Product Change Notice (PCN)

Subject: Assembly factory and front-end process change for Shunt Regulator IC (SOP-8)

Publication Date: 3/11/2024

Assembly process

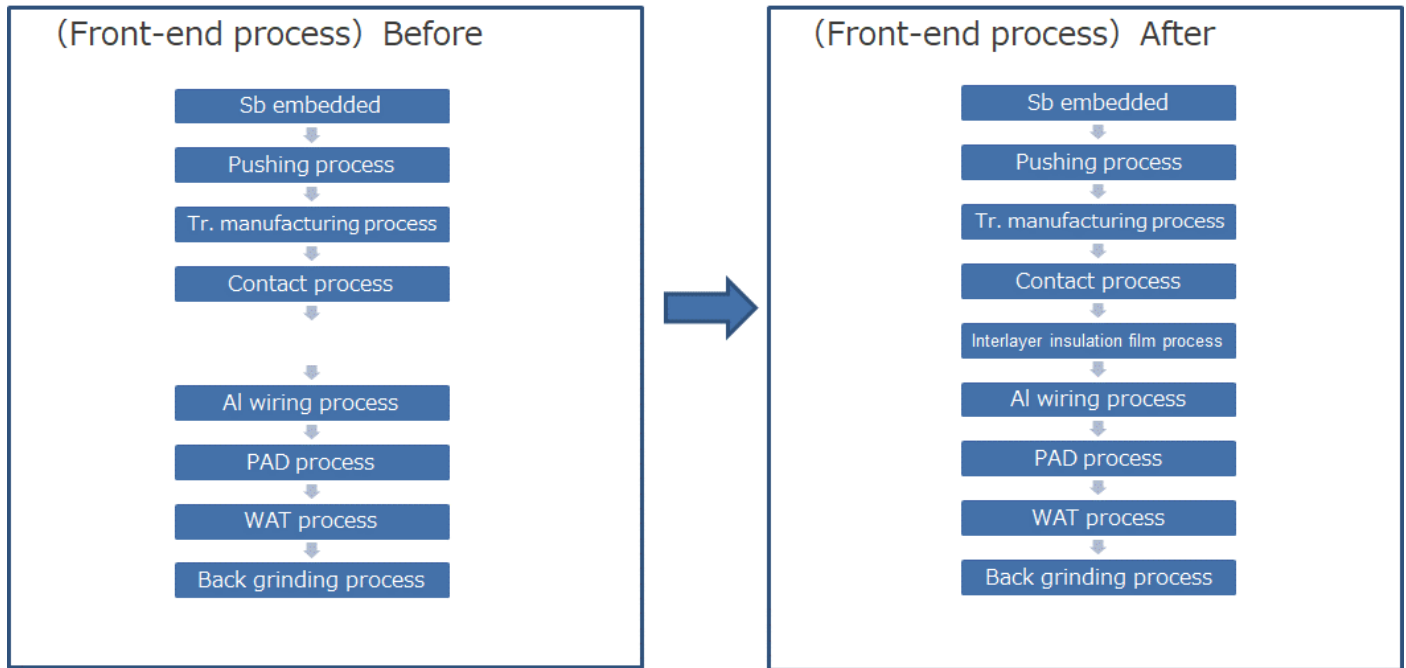
Some materials are different, but these materials have been mass-produced.

Material	Before the change	After the change
Lead flame	Fe-based	Cu-based (Palladium Pre-Plated Lead Frame)
Resin	Epoxy resin	Epoxy resin (Halogen free)
Planting	Sn-Bi	Pd (Palladium Pre-Plated Lead Frame)
Wire	Au(23um)	Au(25um)

<Form>

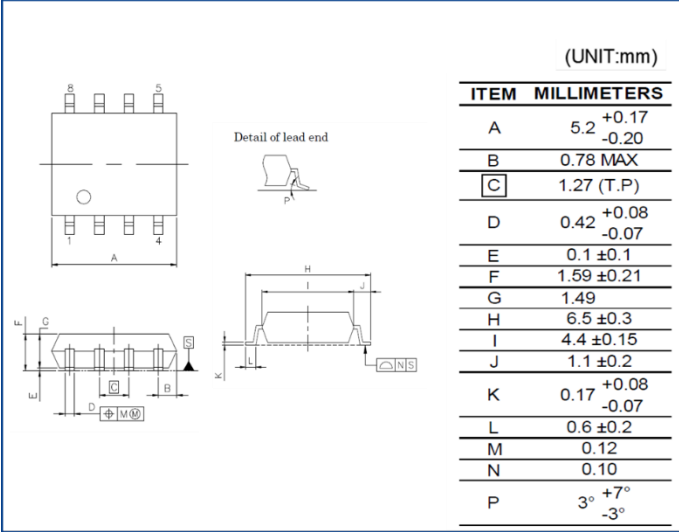
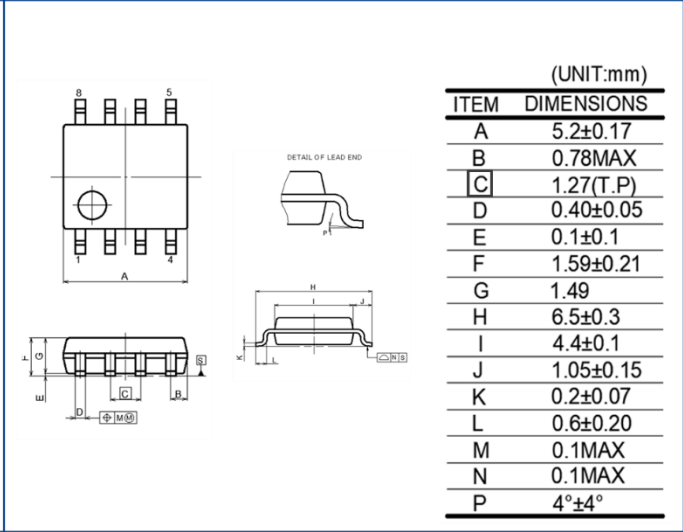
There are some differences in dimensions in the outline drawing, but the recommended foot pattern is not change.

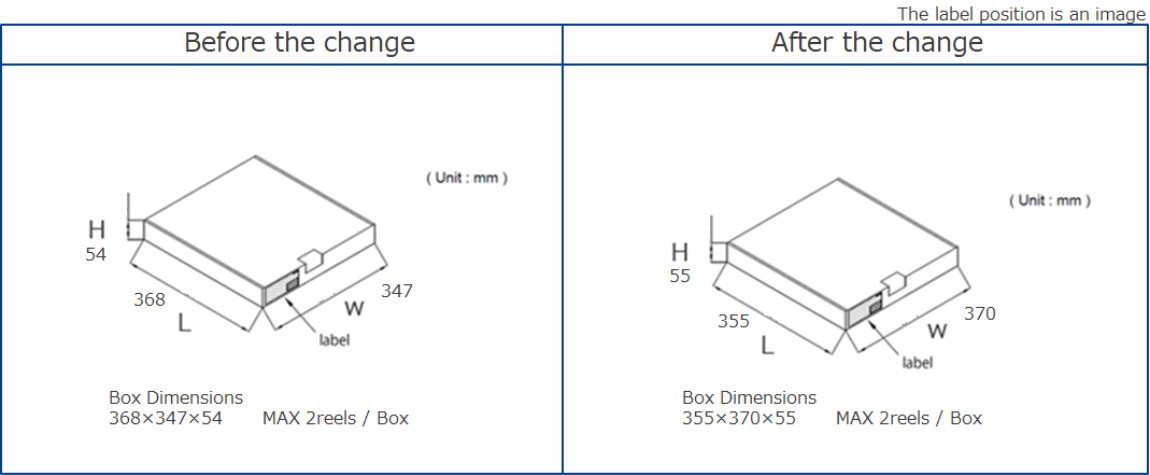
The size of the tape product packaging box changes as shown below.
This is the standard specification that have a proven track record in mass production.

Before (L×W×H)	After (L×W×H)
368×347×54 (mm)	355×370×55 (mm)

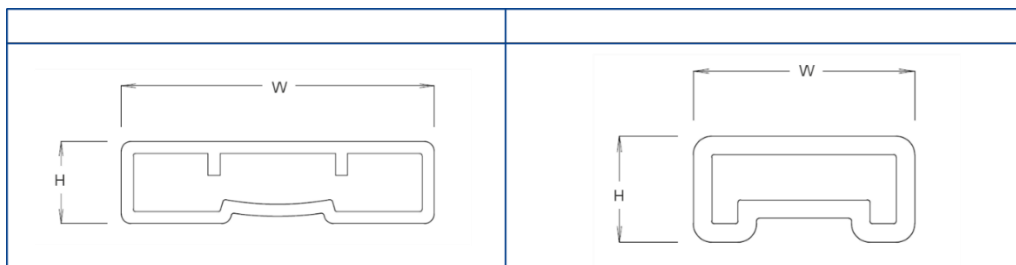
The size of the tube changes as shown below.
This is the open products that have a proven track record in mass production.

Before(L×W×H), Number of packages	After(L×W×H) , Number of packages
530×13×3.4 (mm),Max100 pcs	507~509×8.4×4.0 (mm) ,Max90 pcs

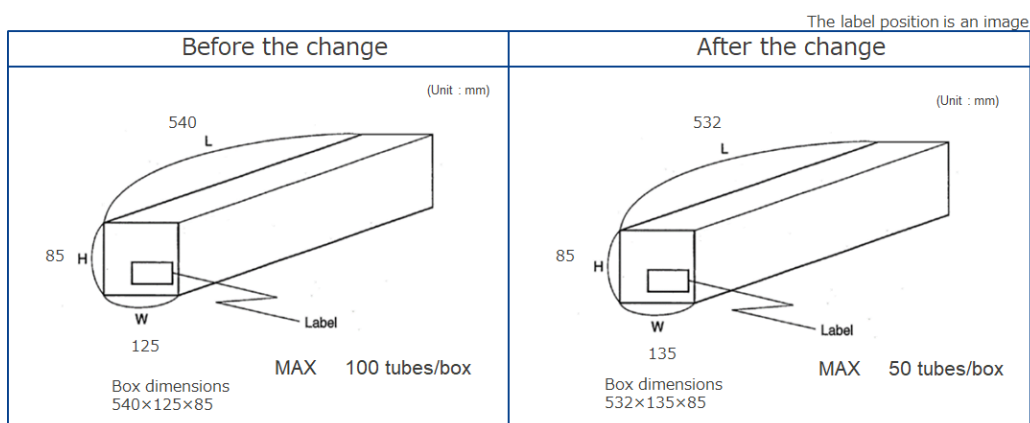
The size of the tube product packaging box changes as shown below.

Before (L×W×H)	After (L×W×H)
540×125×85 (mm)	532×135×85 (mm)

Product identification

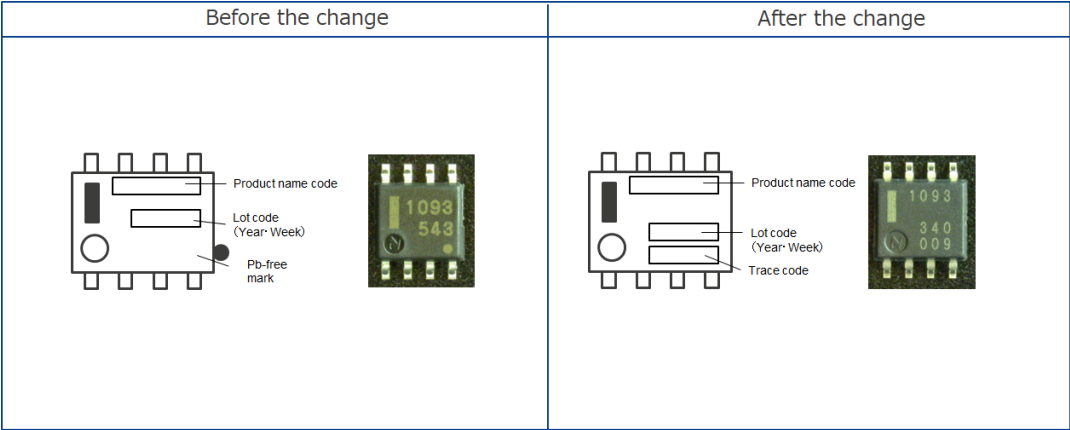
The appearance (Font, Delete Pb-free mark, Add the trace code) of the Mark/ Package Outline of products is different, but Product name code/ Lot code of Mark/Package Outline information is the same.

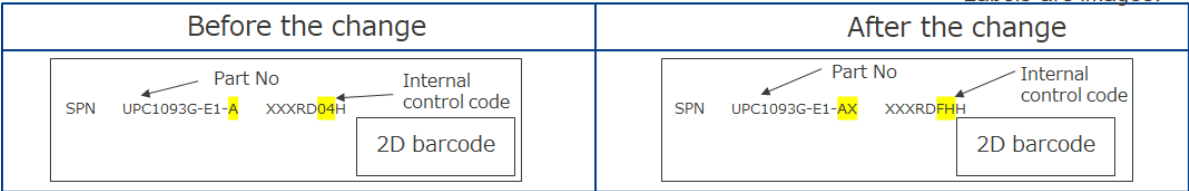
Production sites can be identified by the Labels (Reels, interior boxes).

Item	Before		After
End number of Part No	: -A	→	-AX
Internal control code	: 04	→	FH
